Modification to run CPU09CMI on 5MHz bus.

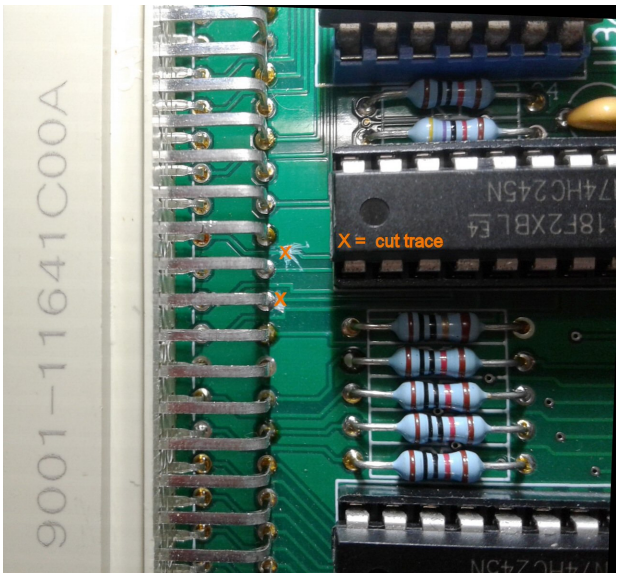
Replace xtal into 20MHz.
Replace C1 and C2 by 15pF.
Place 10M smd between crystal pins.
Replace GAL CMI_1 by CMI-4_1
Only use the HD63C09.

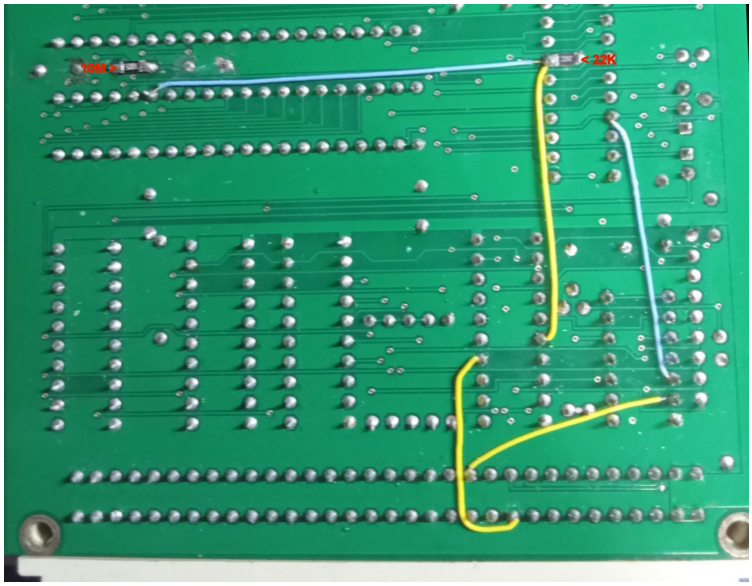
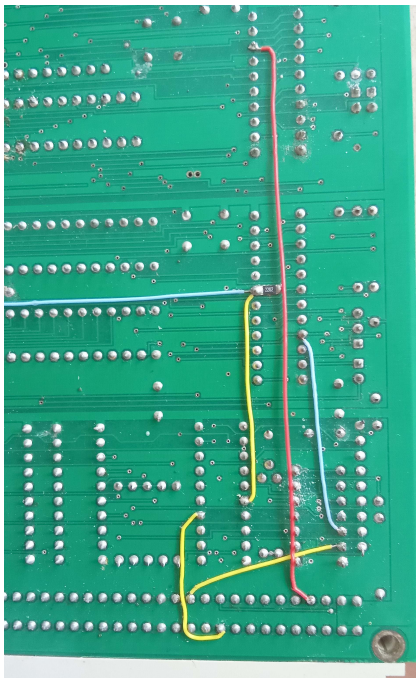
On top side:
Cut trace between U4-14 and J1 C-21 (B_VMA-)
For REV:0.9 print only cut trace from J1 A23 to R15

On solder side:
Cut trace between U13-19 and via (OVMA-)
Place 22K resistor between U13-19 and Gnd
Place wire from U6-35 to U13-19 (blue) and U4-6 (Q) (yellow)
Place wire from U4-14 to J1 A-23 (B_Q) (yellow)
Option: FLPMIN_M. >> Place wire from U14-18 to J1-C29 (red) >>

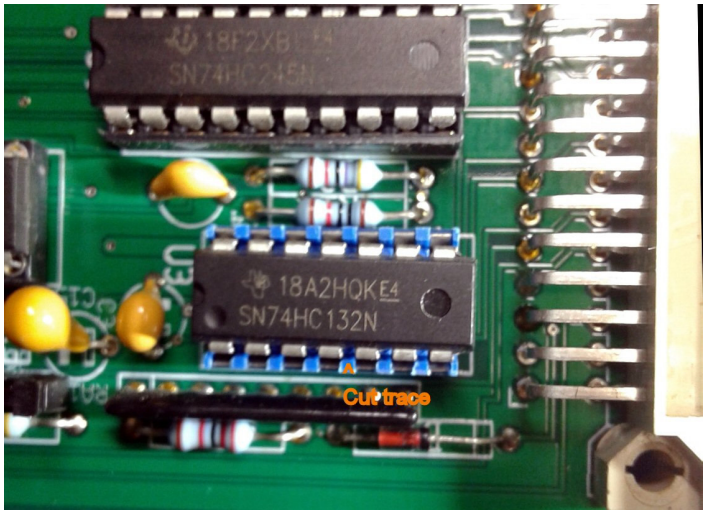
Place wire from U3-7 to J1 C-21 (B_VMA-) , **Or:**
To keep CPU09CMI 68x02 compatible
or need VMA- signal with 68x02 on the bus
for CPU09GPP or CPU09RAM card.

On top side:
Cut trace between U3-4 and U3-5

On solder side:
Place wire from U3-5 to U13-9 (VMA) (blue)
Place wire from U3-6 to J1 C-21 (B_VMA-) (yellow)
